Our Ref: D2023-015

3 & 4 LLANFOYST STREET, RANDWICK

BUILDING CODE OF AUSTRALIA 2022

CAPABILITY STATEMENT FOR DA SUBMISSION

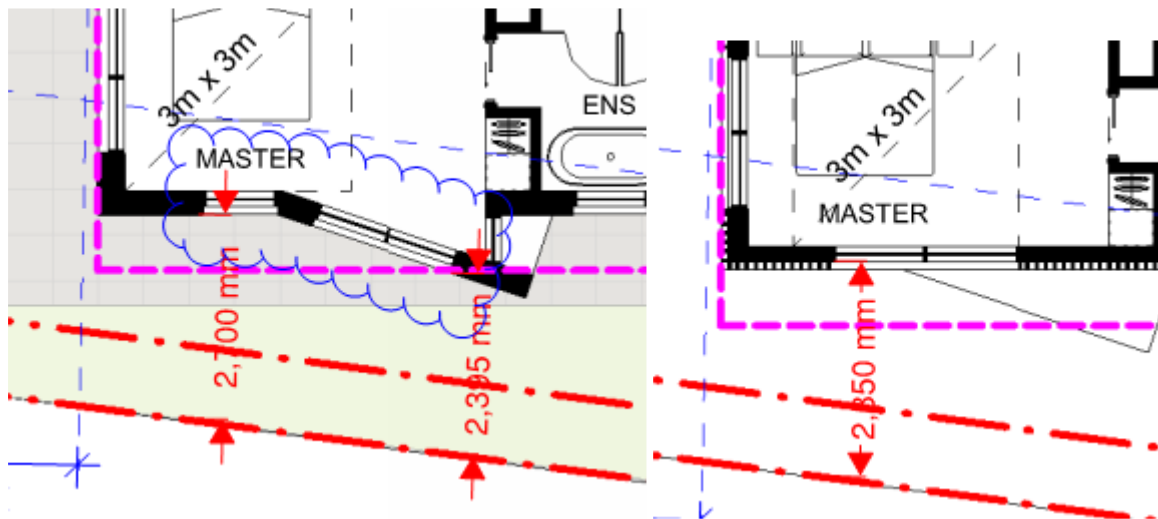
1. The basement car park levels are to adopt class 7a FRL's throughout (generally being 120 minutes) with the slab separating ground floor and part level 1 having a FRL of 120/120/120.
2. Bounding construction between residential sole occupant units (SOU) in class 2 parts are to generally achieve a FRL of 90/90/90 (loadbearing) or -/60/60 (non loadbearing). Note that permitted reductions under Specification 18 are permitted based on sprinkler protection being afforded throughout the building.

The proposed development is capable of achieving the required FRL's, and to be confirmed by the structural engineer, any reduction to FRL's is to be assessed by way of a performance solution.

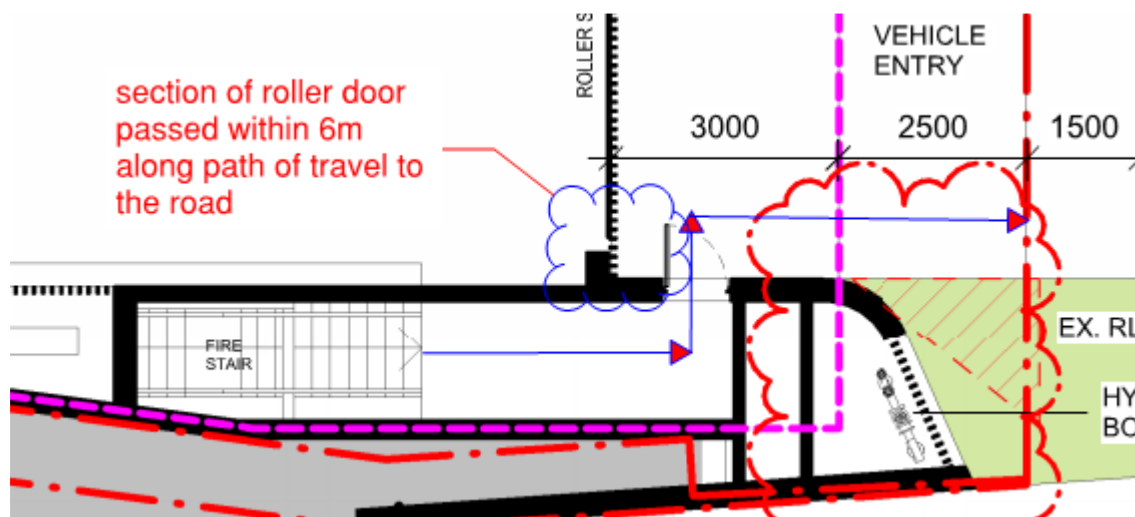
The northern stair is not considered to be designed as fire isolated and are not required to be designed as such to the basement level.

The south stair accessing the fire pump room is required to be fire isolated.

The stair serving the above ground storeys is required to be fire isolated as connects 5 storeys and is proposed as non fire isolated, in this regard the form of the stair including the discharge is to be subject to a performance solution at the construction certificate stage.
